# Syar Alexander Valley Instream Mining Project and Sonoma County ARM Plan Amendments

## Response to Comments Document

SCH# 2006042101

Prepared for  
County of Sonoma Permit  
and Resource Management Department

Figure 3.2-3b  
**Changes in Bar Elevations in the Alexander Valley from 1994 to 2007**

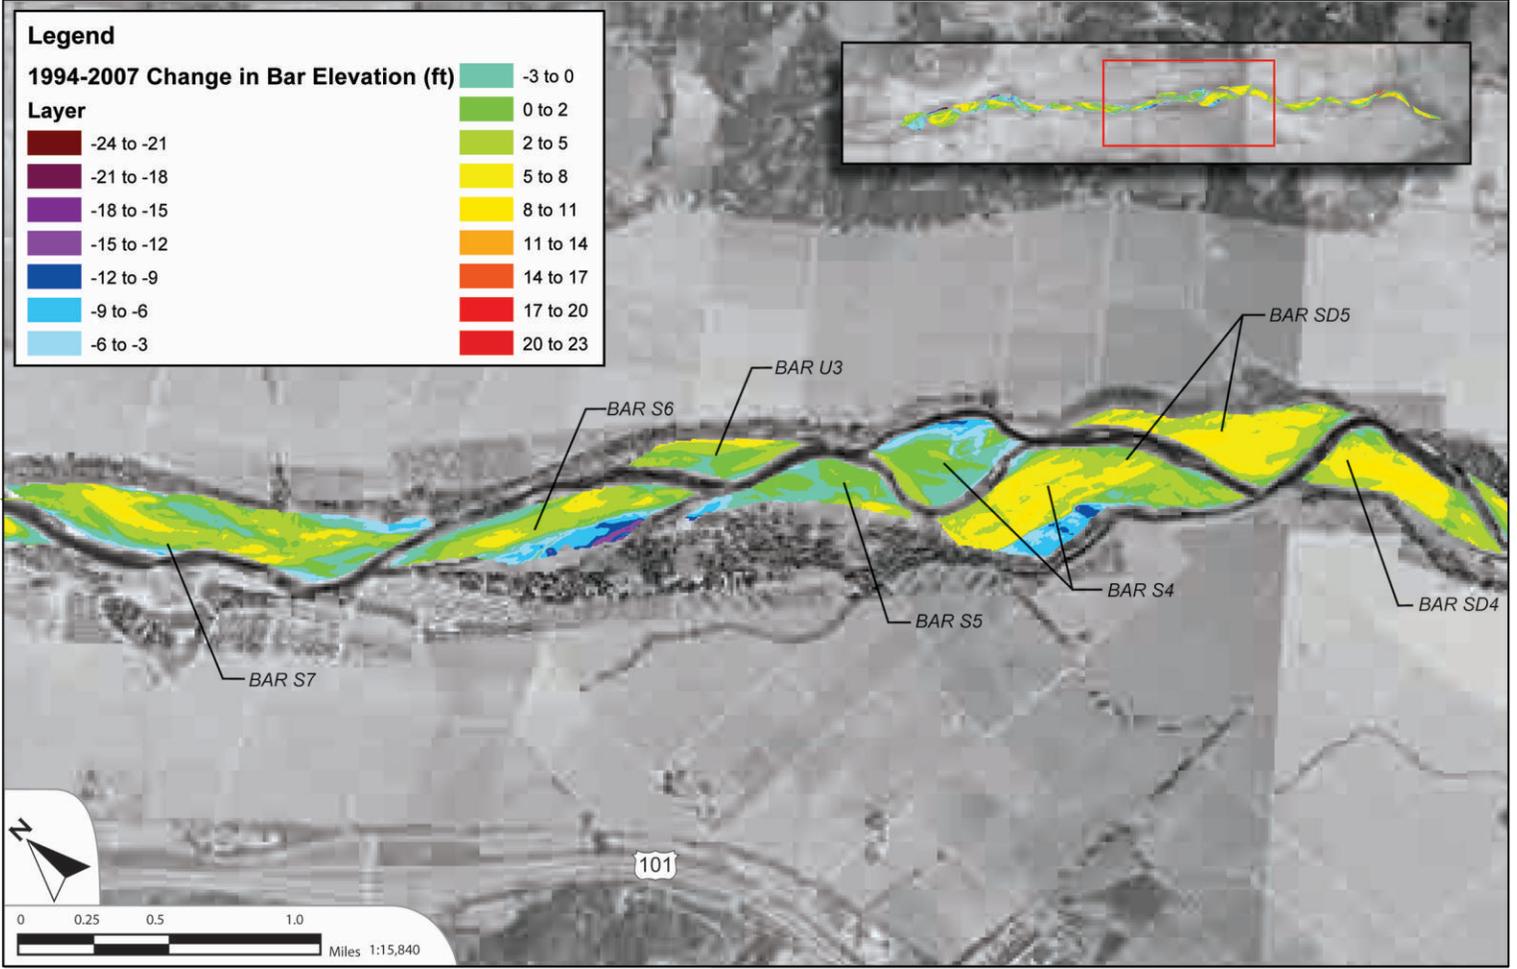
**G-39** **Comment:** What are the error rates for the Digital Terrain Model (DTM) referred to on page 3.2-15? Why doesn't the DEIR mention only that DTM has shown "dramatic increases" in gravel bar height but does not mention that some areas show dramatic decreases in bar height? Doesn't this bias the uninformed reader to believe that bars are only growing? Looking at figures 3.23a-c it is clear that dramatic decreases in

sediment volume have also occurred. In Figure 3.23b the scale used for highlighting change in bar elevation is not equal for increases and decreases as the decrease scale bottoms out at greater than 8ft but the other side tops out at 12-16 ft again giving a highly biased view of the change in bar heights. Why did the DEIR use different scales for figure 3-2-3b? What are the error rates for these figures and where is the calculation for that error rate?

Page 3.2-18 of the Draft EIR, Figure 3.2-3b is revised to present the correct graphic.

An incorrect version of Figure 3.2-3b was included in the DEIR. The correct graphic is attached as part of this Response to Comments Document, as shown in Section 2.0, "Revisions to the Draft EIR".

Figure 3.6-1  
 Syar Alexander Valley  
 In-Stream Mining Project Study Map

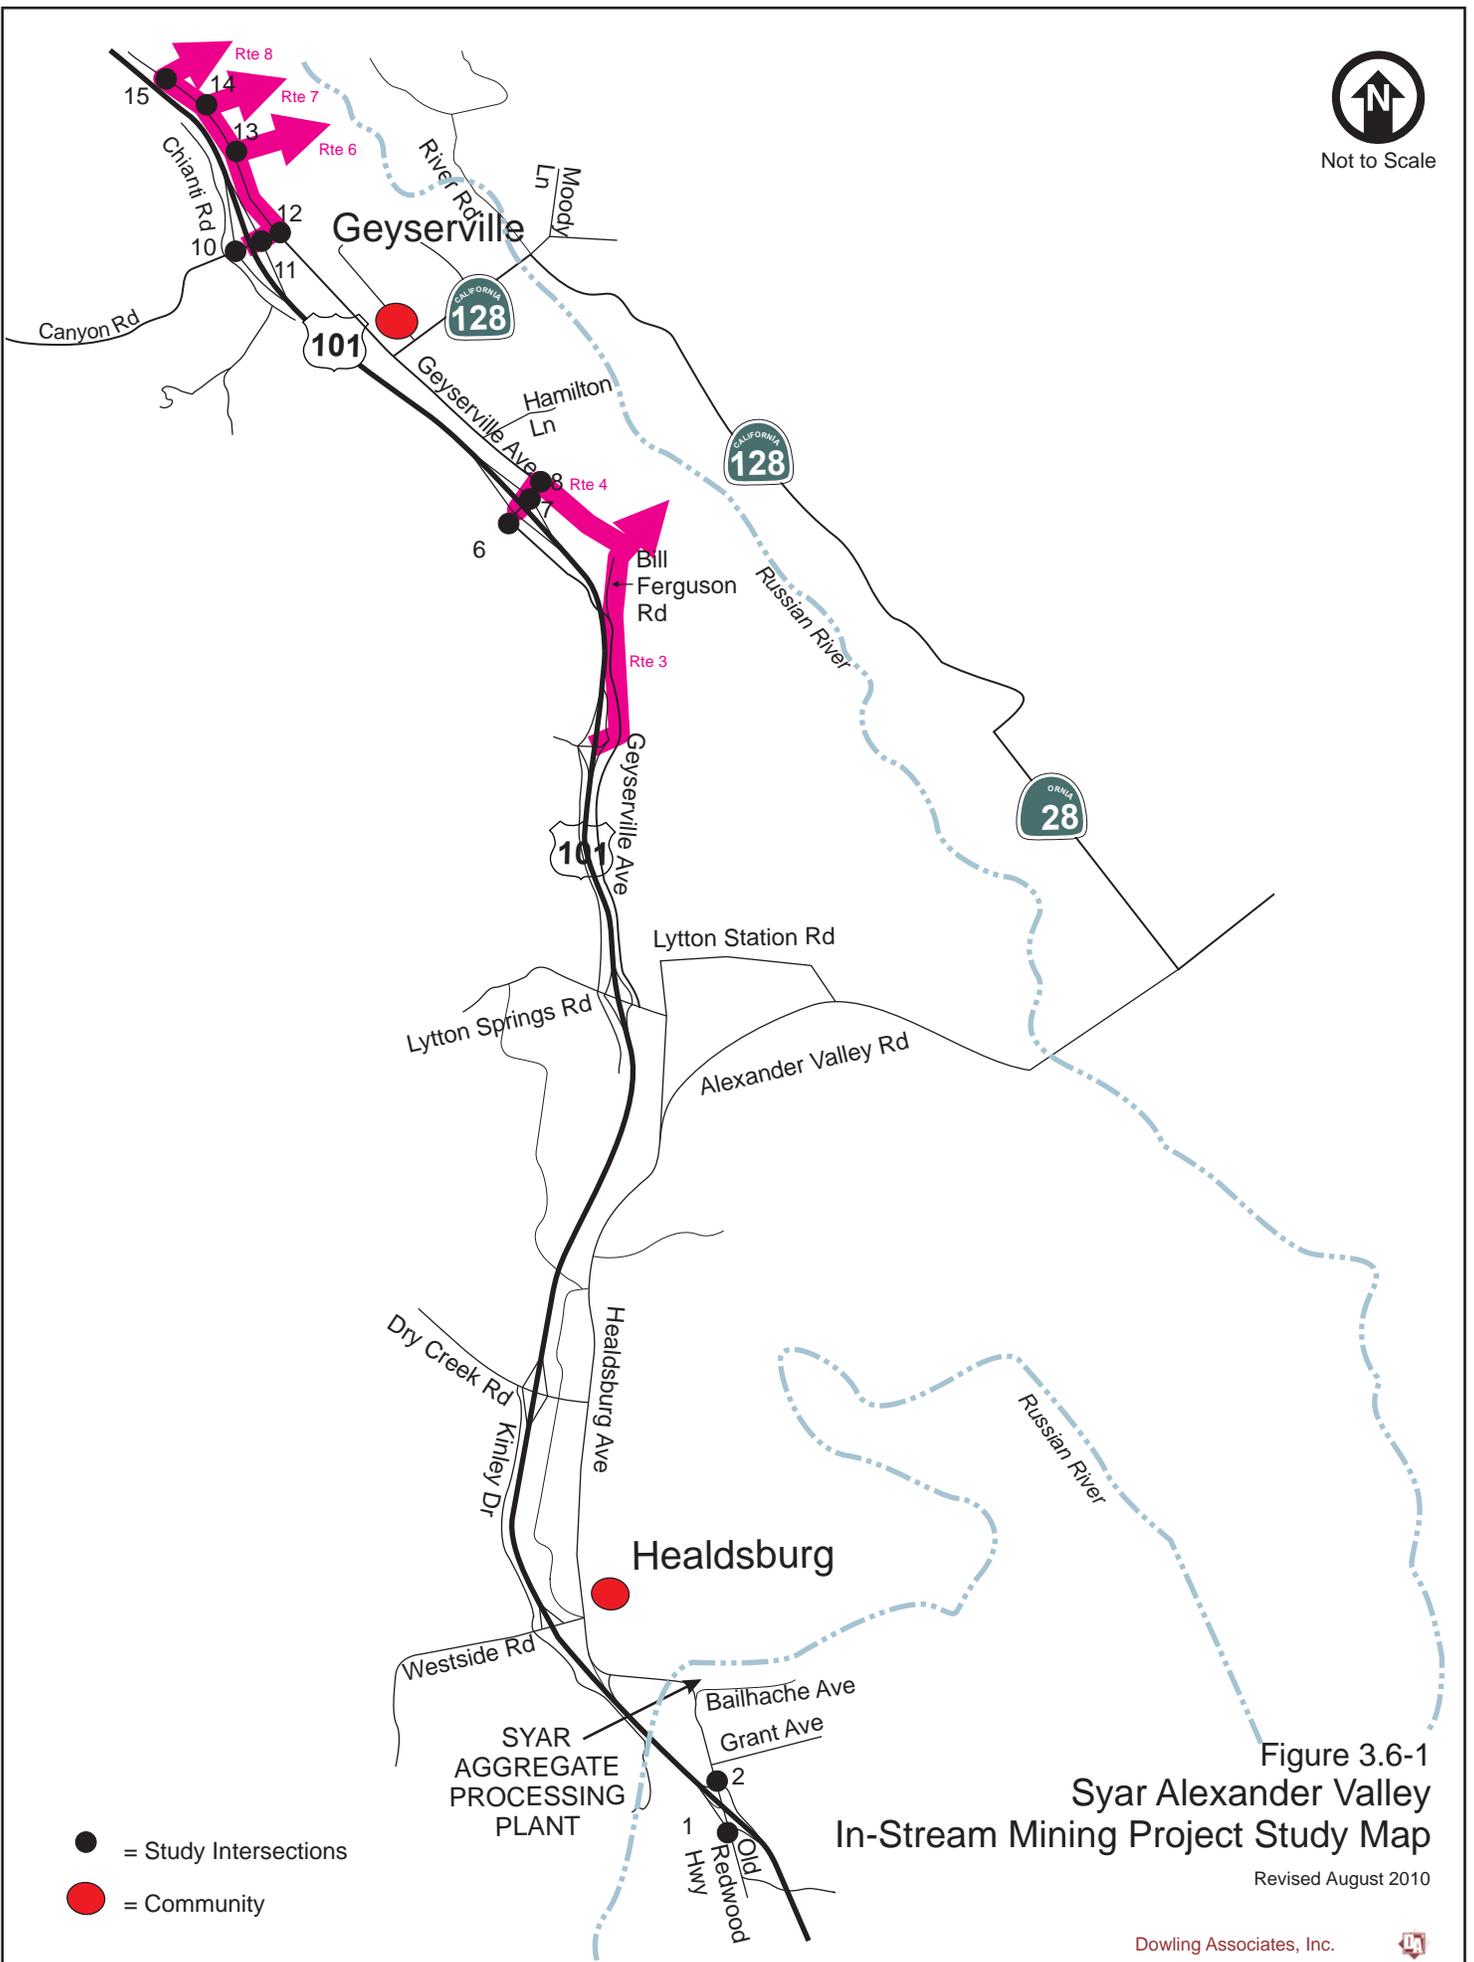
Page 3.6-5 of the Draft EIR, Figure 3.6-1 is revised to reflect the elimination of Haul Routes 2 and 5 from the proposed project.

**Figure 3.6-2**  
**Syar Alexander Valley**  
**In-Stream Mining**  
**Existing AM(PM) Volumes**

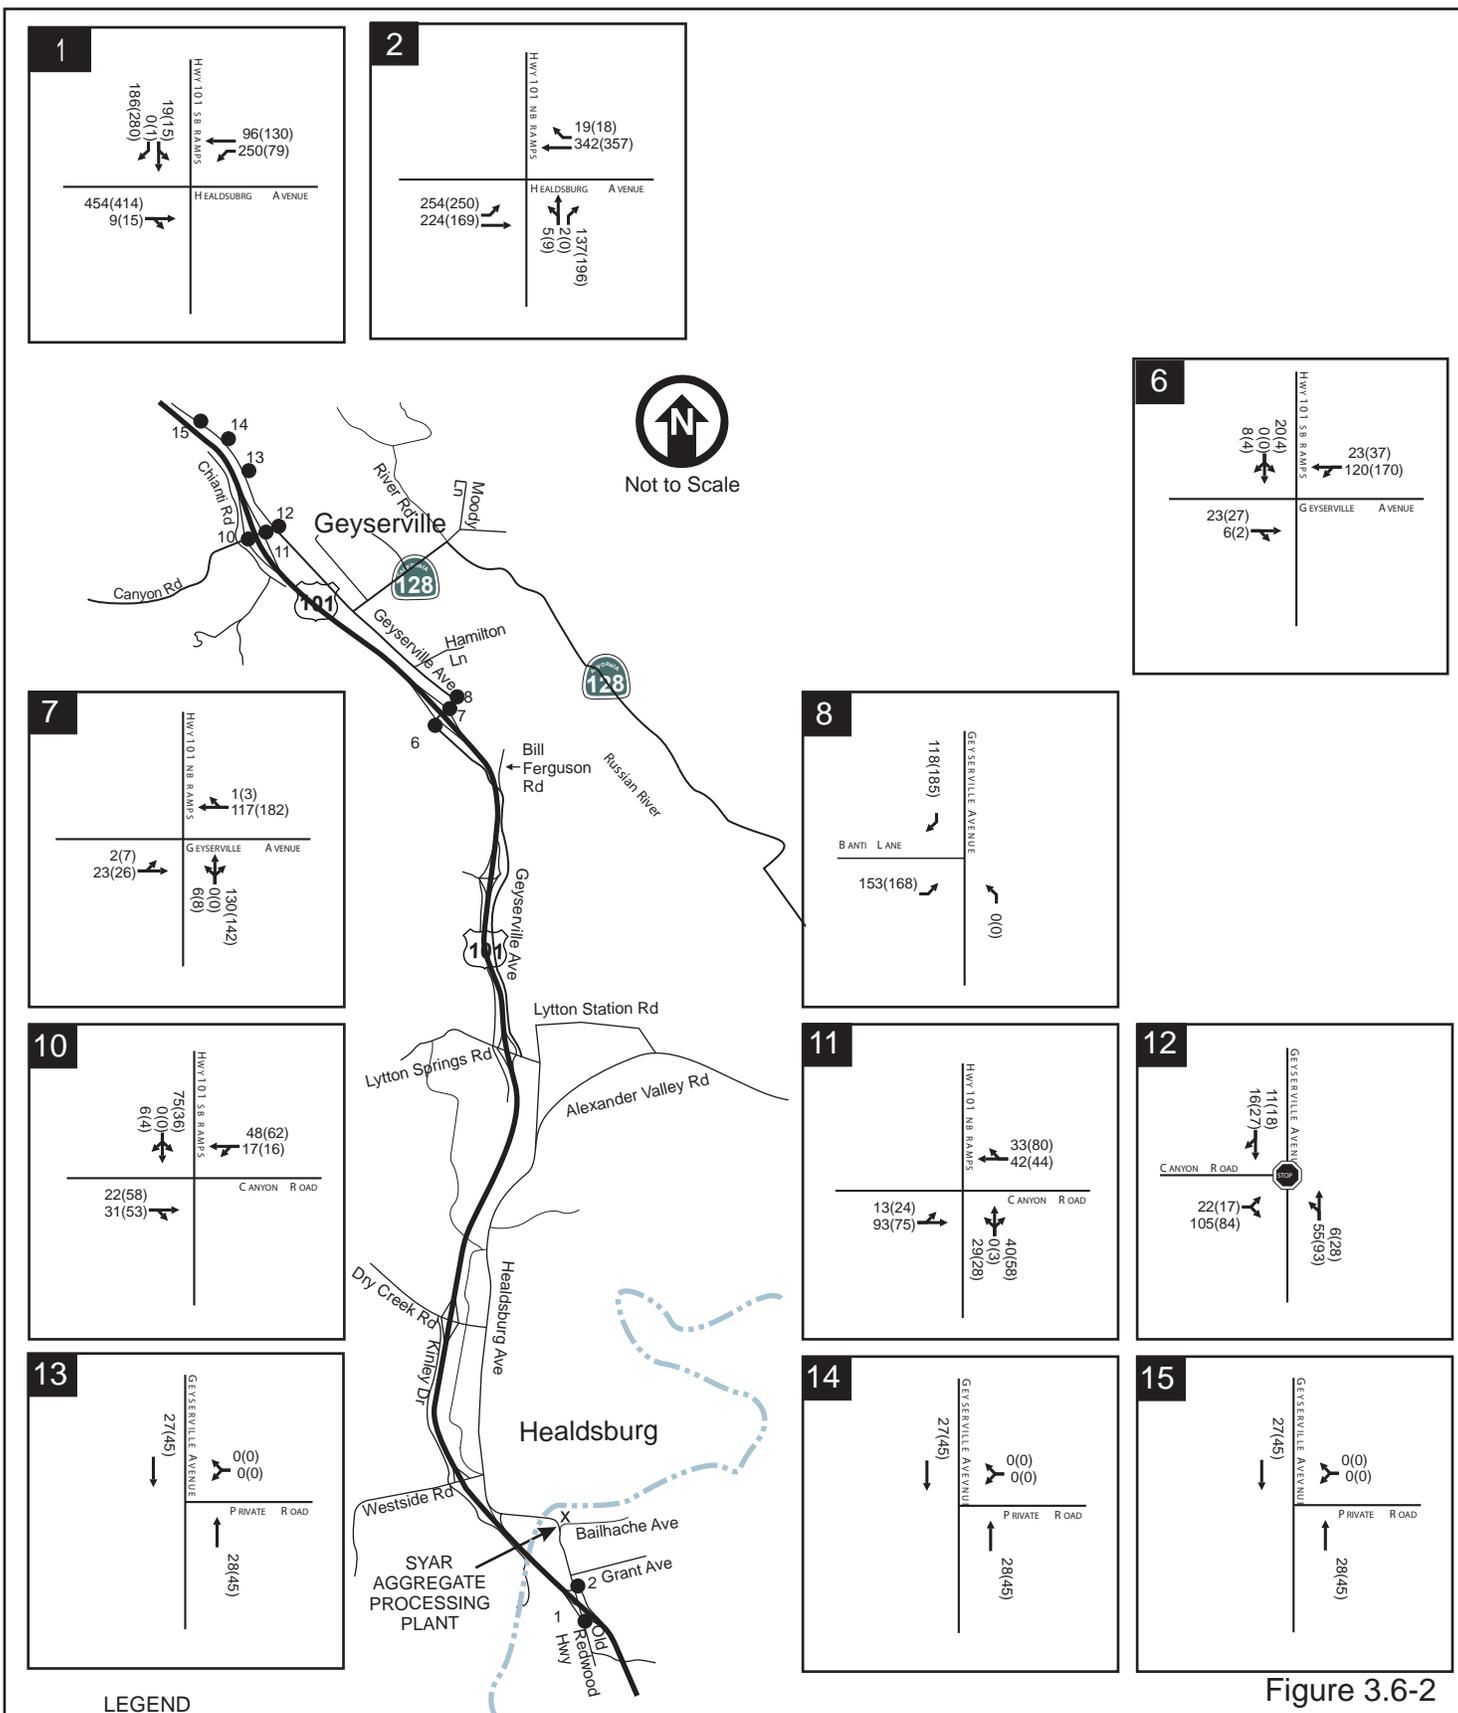
Page 3.6-9 of the Draft EIR, Figure 3.6-2 is revised to reflect the elimination of Haul Routes 2 and 5 from the proposed project.

Figure 3.6-3  
 Syar Alexander Valley  
 In-Stream Mining Project Only  
 AM(PM) Volumes

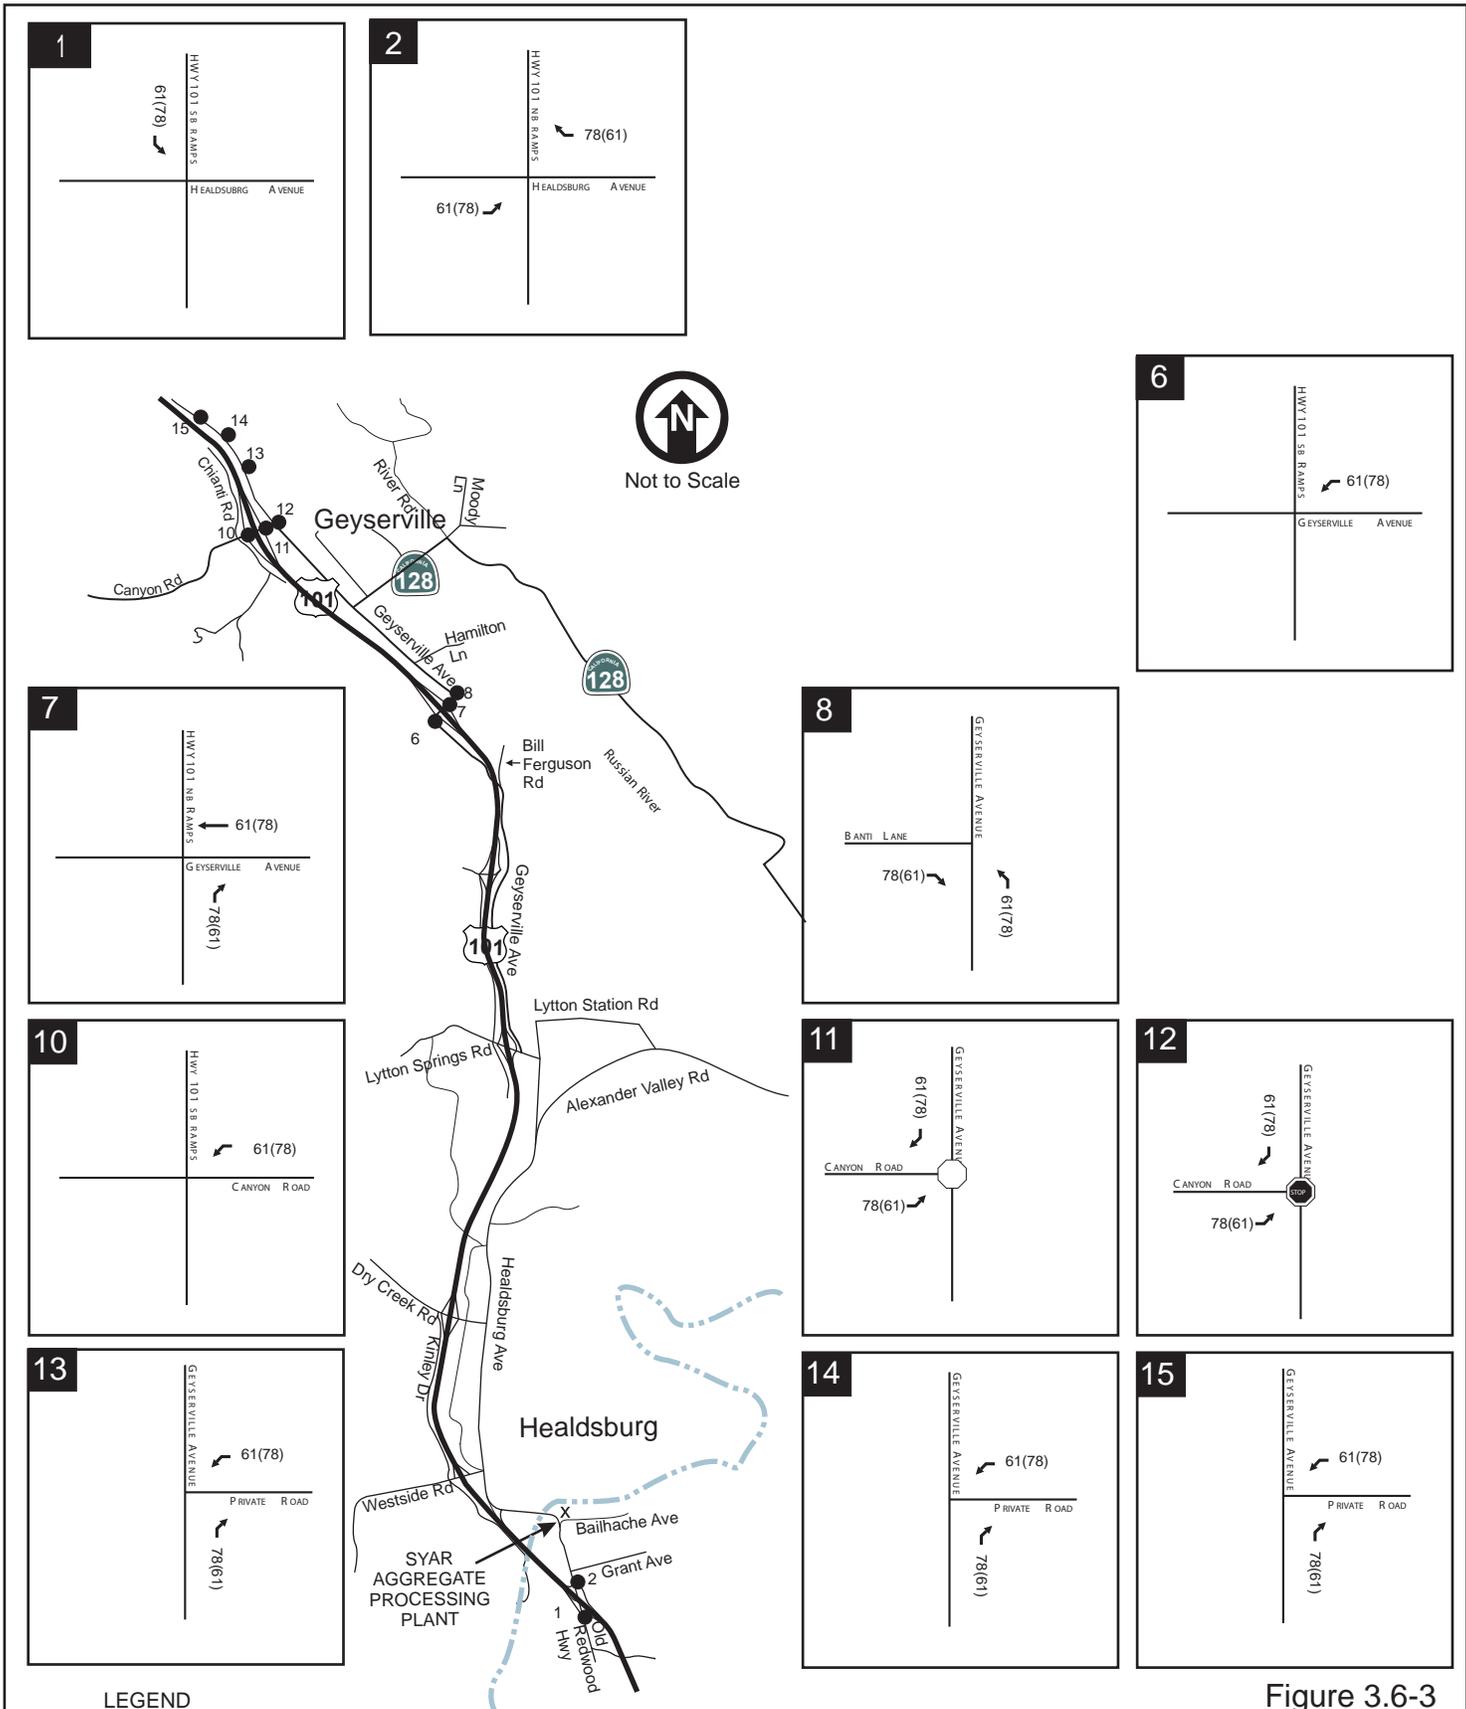
Page 3.6-19 of the Draft EIR, Figure 3.6-3 is revised to reflect the elimination of Haul Routes 2 and 5 from the proposed project.
